## Proposal for Supplement 8 to the 04 series of amendments to UN Regulation No. 41 (Noise emissions of motorcycles)

### Submitted by the Working Party on Noise and Tyres\*

The text reproduced below was adopted by the Working Party on Noise and Tyres (GRBP) at its seventy-first session (ECE/TRANS/WP.29/GRBP/69, paras. 3 and 5). It is based on Annexes II and III to the report and ECE/TRANS/WP.29/GRBP/2019/24. It is submitted to the World Forum for Harmonization of Vehicle Regulations (WP.29) and to the Administrative Committee (AC.1) for consideration at their June 2020 sessions.

"2.4.1 Positioning of the microphone (see Appendix 2)

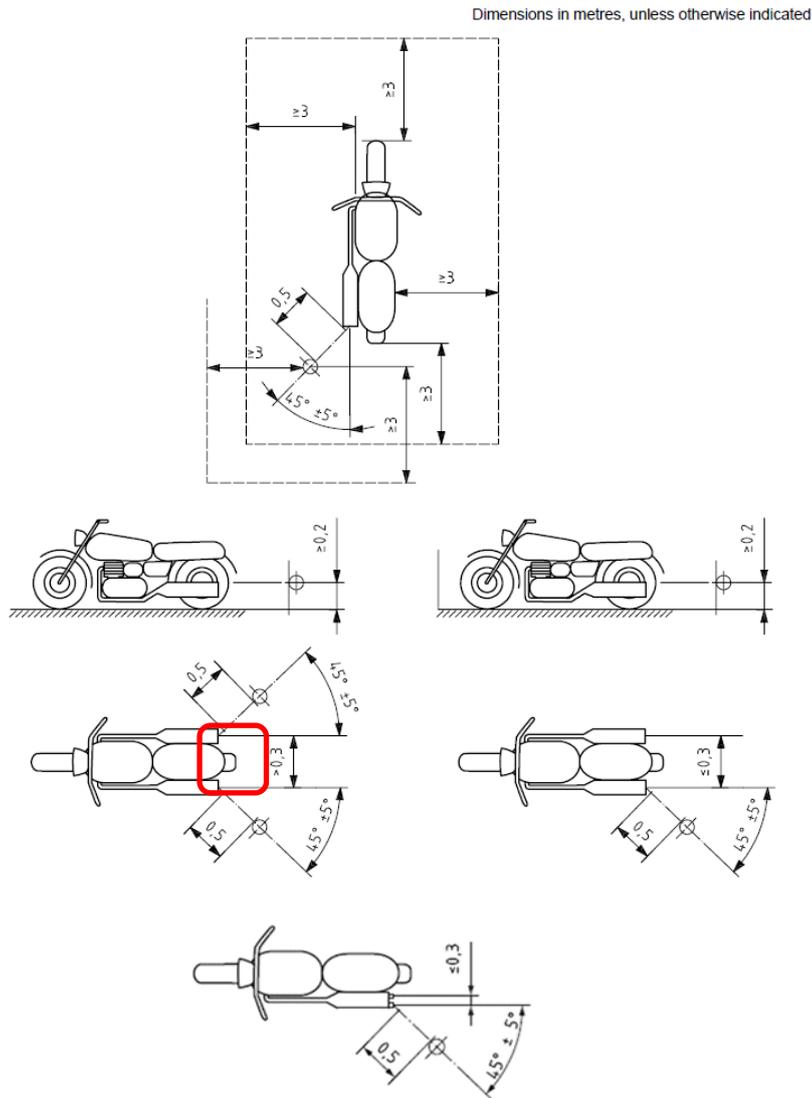
If a vehicle has two or more exhaust outlets spaced less than or equal to 0.3 m apart and connected to a single silencer, only one measurement shall be made. The microphone shall be located relative to the outlet furthest from the vehicle's longitudinal centreline, or, when such outlet does not exist, to the outlet that is highest above the ground. The 0.3 m measurement is to be made along a single plane perpendicular to the flow axis of the exhaust gases.

If a vehicle has two or more exhaust outlets spaced less than or equal to 0.3 m apart and connected to separate silencers, only one measurement shall be made. The microphone shall be located relative to the outlet furthest from the vehicle's longitudinal centreline, or, when such outlet does not exist, to the outlet that is highest above the ground.

For vehicles having an exhaust provided with outlets spaced more than 0.3 m apart, one measurement is made for each outlet as if it were the only one, and the highest sound pressure level shall be noted. For the purpose of roadside checking, the reference point may be moved to the outer side of the body."
